# P4 Side Guard Assist On/Off Menus and Trailer Functionality

FIELD SOLUTION: TSB-54-381-FTL

PUBLISH DATE: 3/17/2026

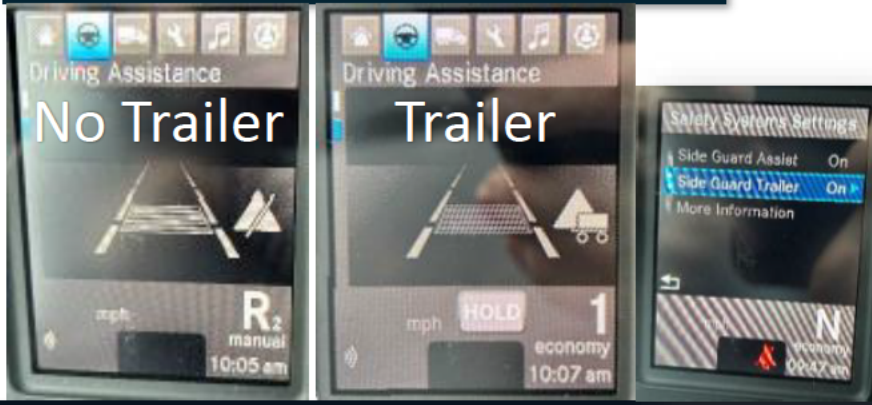
- Trailer detection is not reliable on suspect population which leads to Trailer sweep assist and Active Side Guard assist to react to a suspected trailer when in fact there is no trailer.
- Currently drivers need to deactivate trailer SGA in the menu every key cycle when driving bobtail
- Vehicles can apply breaks when Active side guard assist predicts a possible collision with non-existent trailer

- New air pressure switch and parameters added to trailer air supply line.
- 1/26/2026

- TSB 54-381 goes over the installation of the air pressure switch to the trailer air supply line behind the dash. The parameters have been setup correctly since launch of P4 but the air pressure switch was not present to allow the SSAM to determine the presence of a trailer.
